Rezoning Transportation Analysis

Petition Number: 2019-128

Date	Description
10-21-2019	First Review

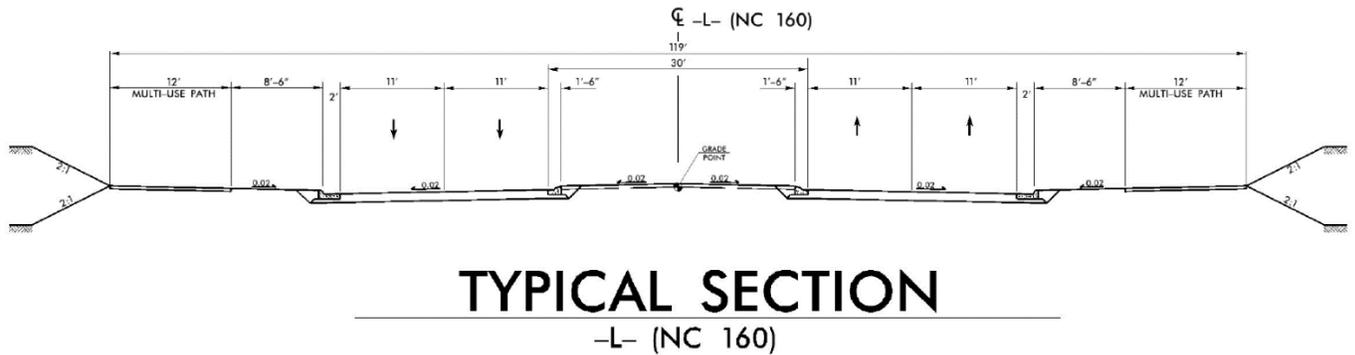
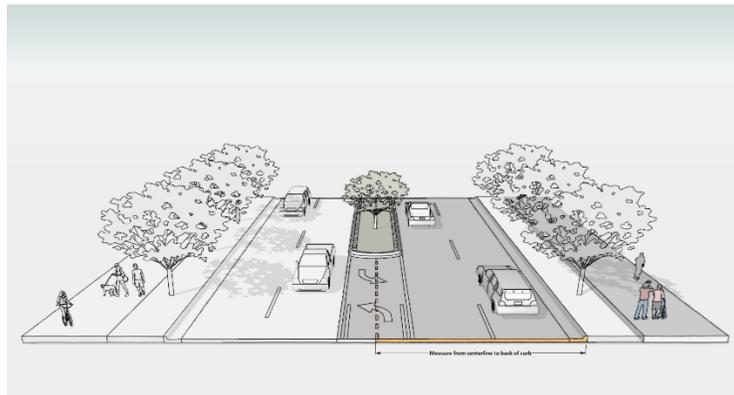
1. **Curbline** The proposed zoning district has a setback measured from back of the existing or proposed future curbline.
 - a. **Steele Creek Road:** The future location of curb and gutter will be constructed within the Steele Creek Road (NC 160) U-5766 project. The public meeting map and proposed cross section are provided below for reference.

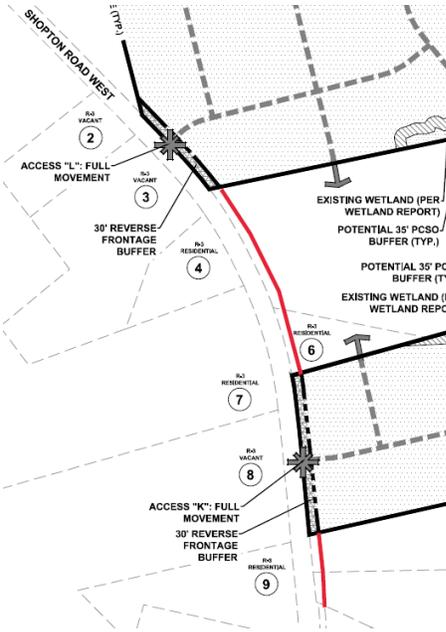
2. **Traffic Study** A Traffic Impact Study is necessary for the complete review of this petition. The petitioner has not finalized the TIS scope with CDOT and NCDOT. Transportation improvements are to be determined, and future additional comments should be expected. The petitioner shall update Conditional Notes 4.I. Transportation Improvements and Access: Proposed Improvements and Conditional Note 4.II.b. Standards, Phasing and Other Provisions (Phasing), to include the transportation improvements and phasing.

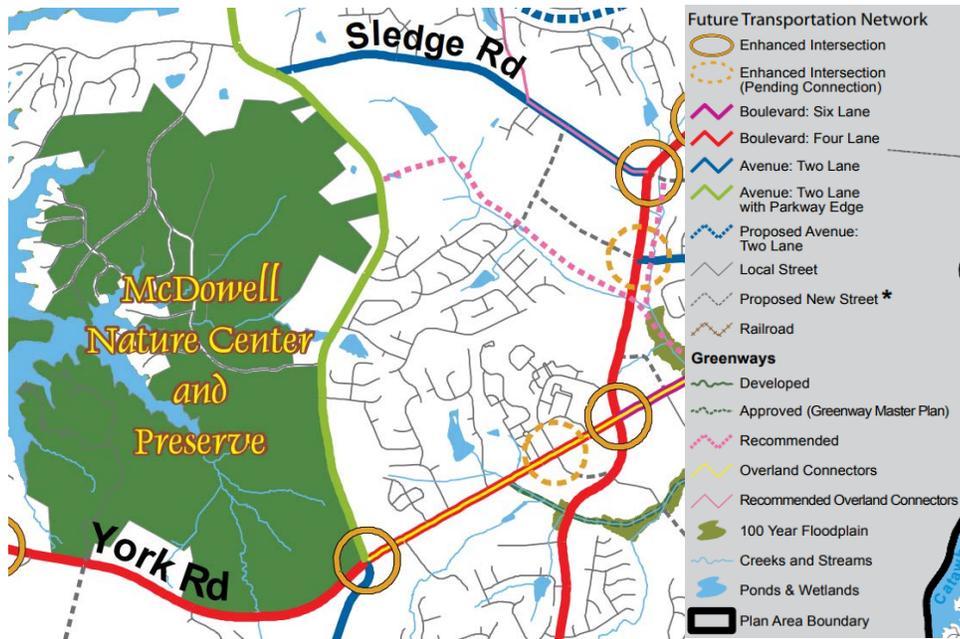
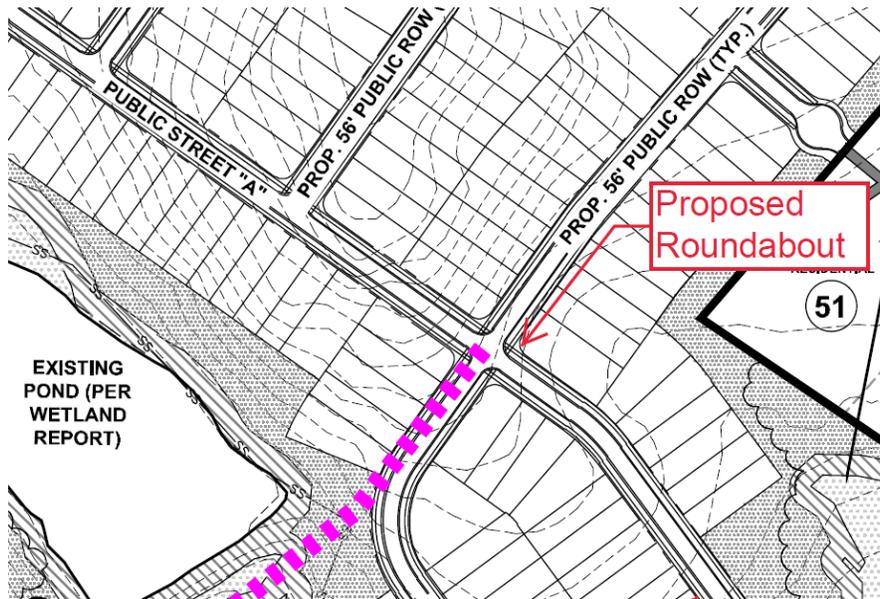
- The petitioner should revise the site plan and conditional note(s) to incorporate a proposed mini-roundabout on proposed Public Street "A."

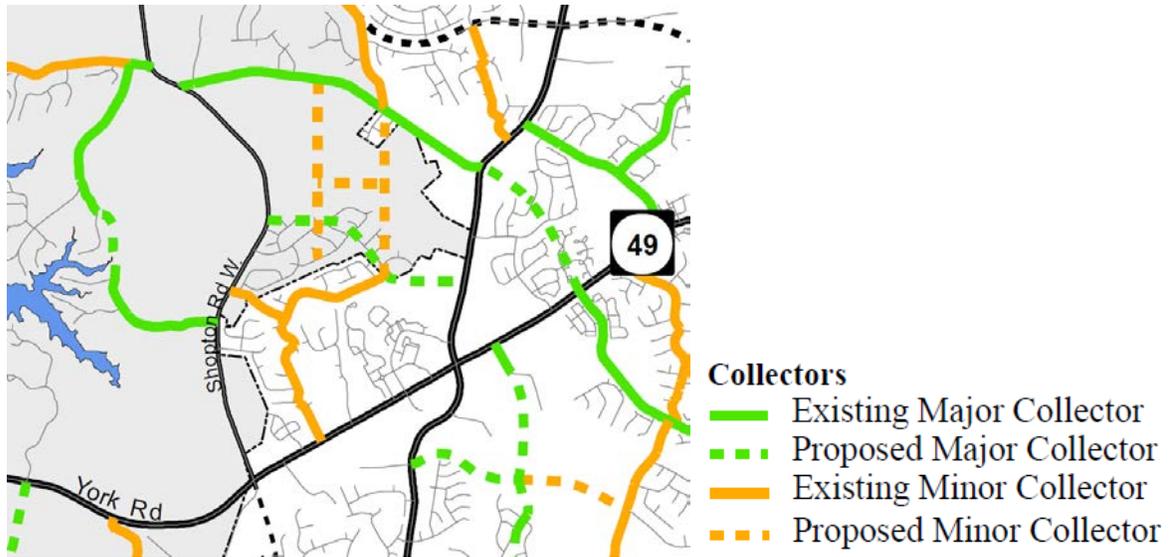
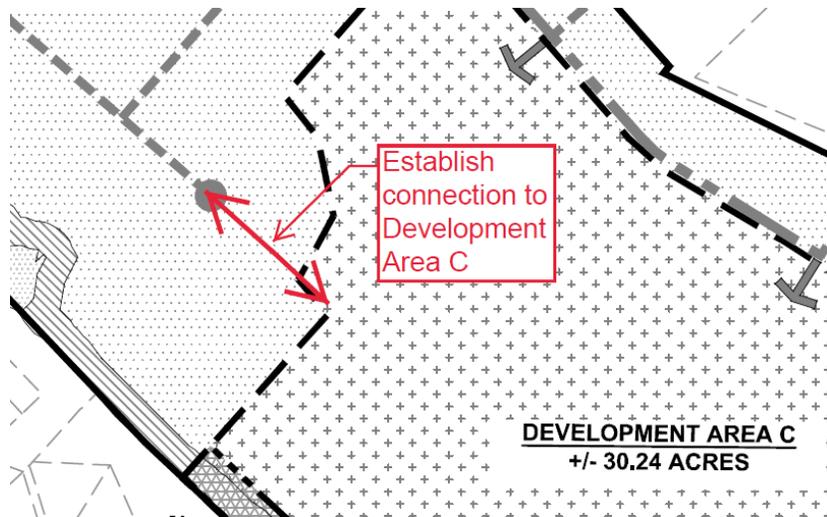
- The petitioner should revise the site plan and conditional note(s) to revise Public Street "A" to a Local Collector Street Section, per CLDSM U-07, as required by Sec. 20-23(k) of the Subdivision Ordinance and the City-council adopted Collector Street Map. In-lieu of the proposed 10-foot multi-use path, a 12-foot multi-use path should be provided along the western streetscape to provide an overland connector to the recommended greenway alignment to the McDowell Nature Center and Preserve.
